SUBJECT: TVA-SEQUOYAH  
ENGINE GOVERNOR ACTUATOR ELECTRICAL CONNECTING PLUG

10CFR21-0027

10CFR21 COMMITTEE MEETING HELD SEPTEMBER 6, 1985

COMPONENT: Engine Governor Actuator Electrical Connecting Plug

FIG-1

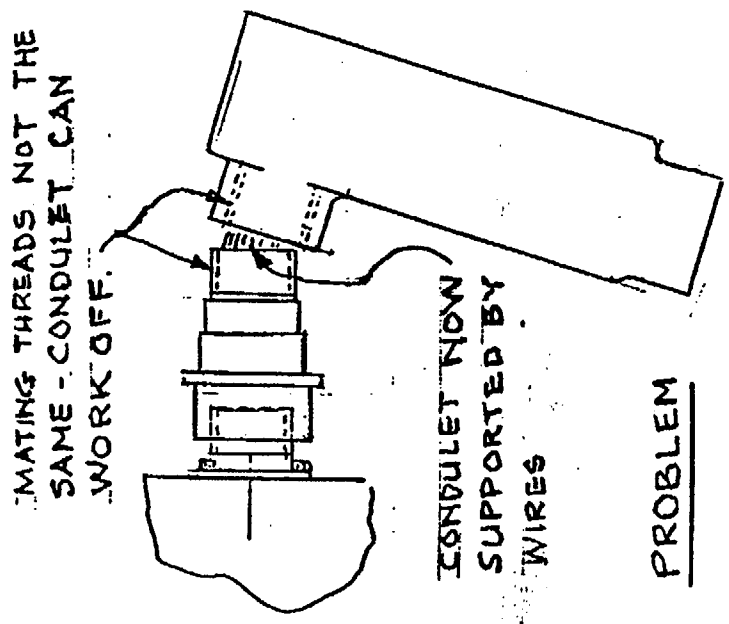
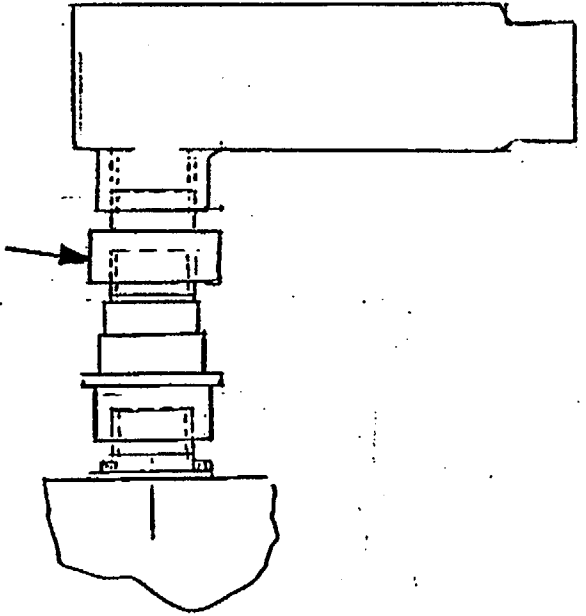
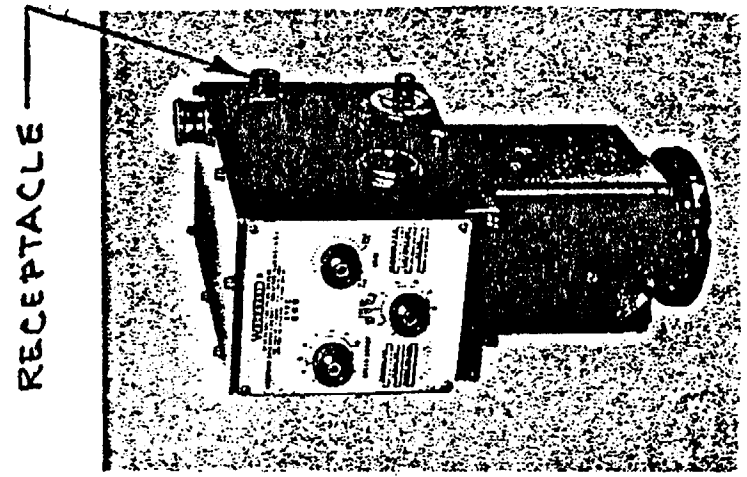
PROBLEM: Improper threads on electrical thread connectors to flexible conduit.

Fig. 1 illustrates the problem. The governor actuator is mounted on the diesel engine. A typical governor is shown in Fig. 1 on which an electrical receptacle is identified. All the electrical signals for the electric portion of the governor, the hydraulic governor speed setting motors, the shutdown solenoid and limit switches are supplied through this receptacle.

For diesel-generators furnished prior to 1976, the arrangement as shown on Fig. 1 "Installation" may have been furnished showing the connections to this receptacle. The problem is that the threads in the conduit are not the same as the mating threads on the plug. While the assembly appeared to be tight, there is a potential for the thread joint to loosen, particularly when subjected to engine operating vibration, with the conduit eventually working free. Then the only support for the flexible conduit that connects the plug to the control panel is the control wires inside. The potential then exists for the possible shorting or breaking of wires as a result of operating vibration; thereby, interrupting the signals to the governor and preventing the diesel-generator from performing its safety function.

INSTALL ADAPTER 802020

The corrective action is to install an adapter P.N. B02020 which provides the correct threads for each component.
